Causal pulse shape and tap limits

(comments I-468 , R1-282 and R2-204)

Piers Dawe

chayeb 3dj 01 2505 slides 8 and 9

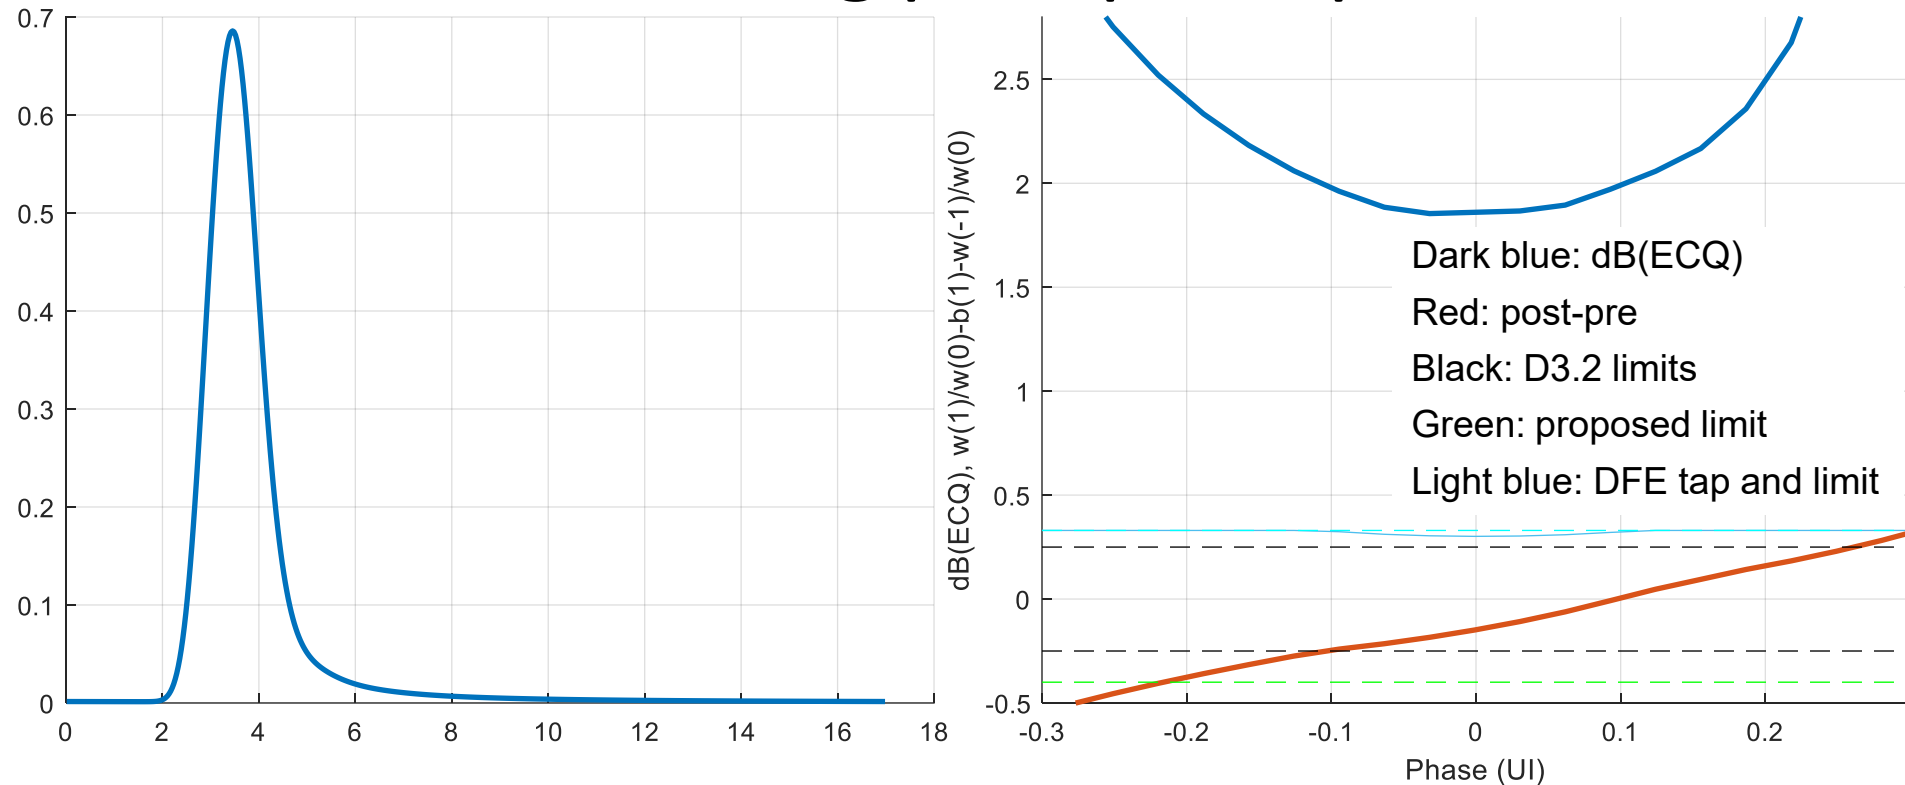
Experimental Data: “Good” TDECQ, “Bad” Link Performance

**Experimental Data:
“Bad” TDECQ,
“Good” BER**

Red when there is post-FEC error

Cost of force-fitting post-pre tap difference

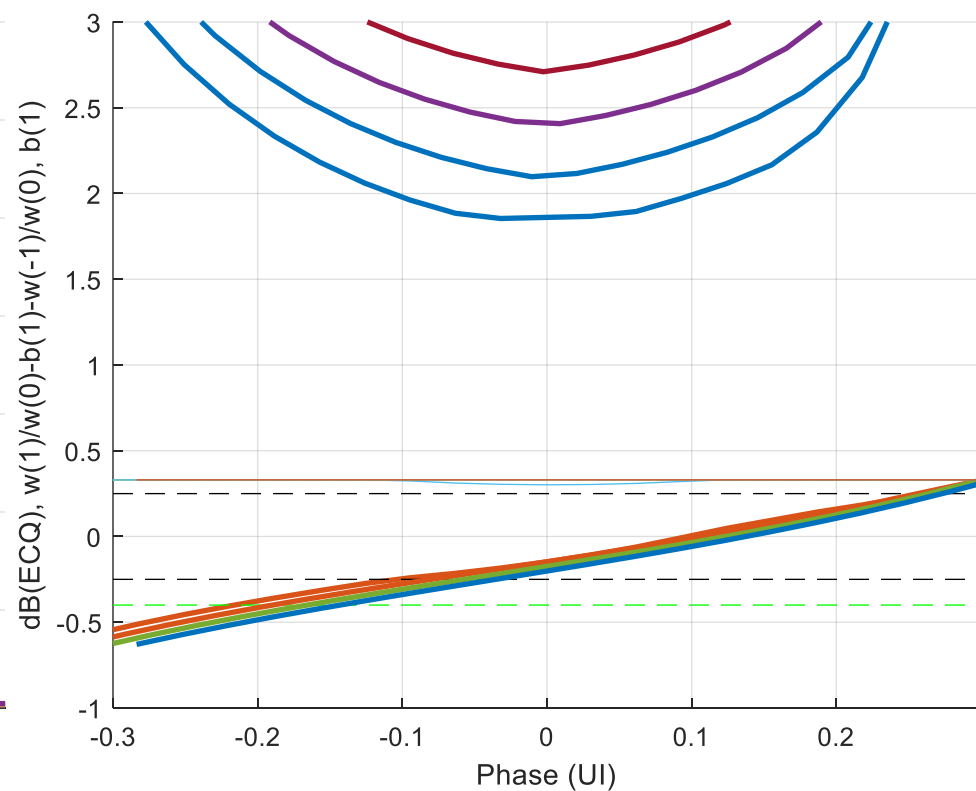
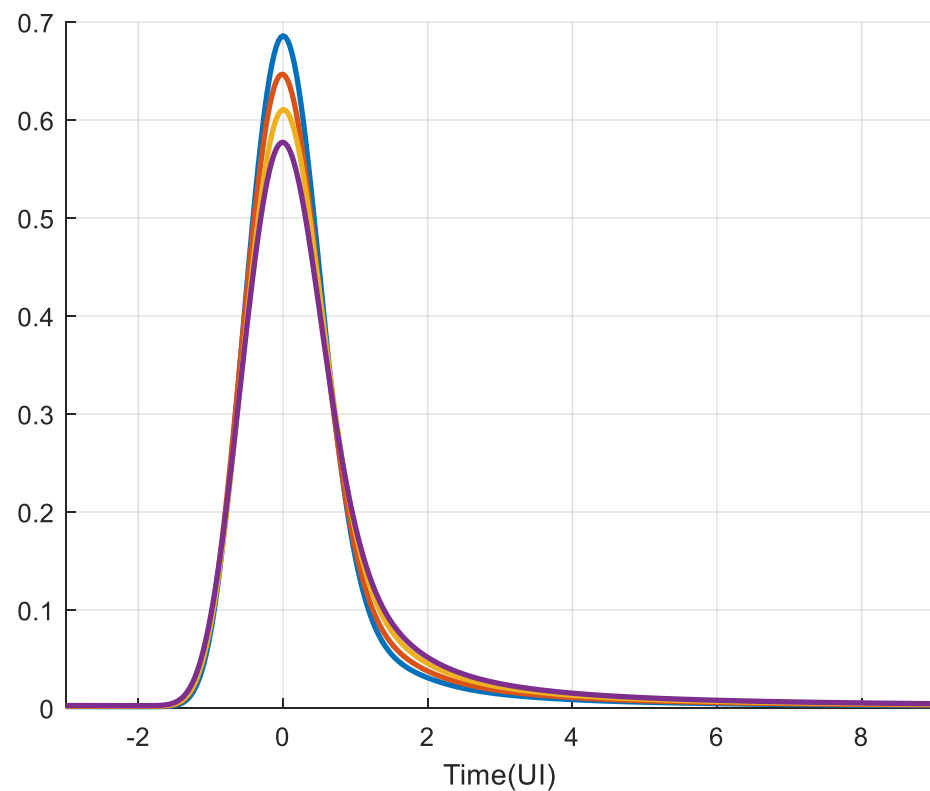
- Left: example "causal" (natural, normal) pulse shape: fast attack, slow decay
 - More skew than this is commonplace
- Right: sweeping sampling phase. Best is where post-pre is -0.15 UI. This is an ideal simulation (no jitter); in practice the sweet spot would be narrower
- There is almost equal timing offset penalty at -0.2 UI and 0.2 UI where post-pre is -0.38 and +0.16
- The proposed limits are a significant improvement

- Stepping the loss in 1 dB steps
- Best post-pre remains offset
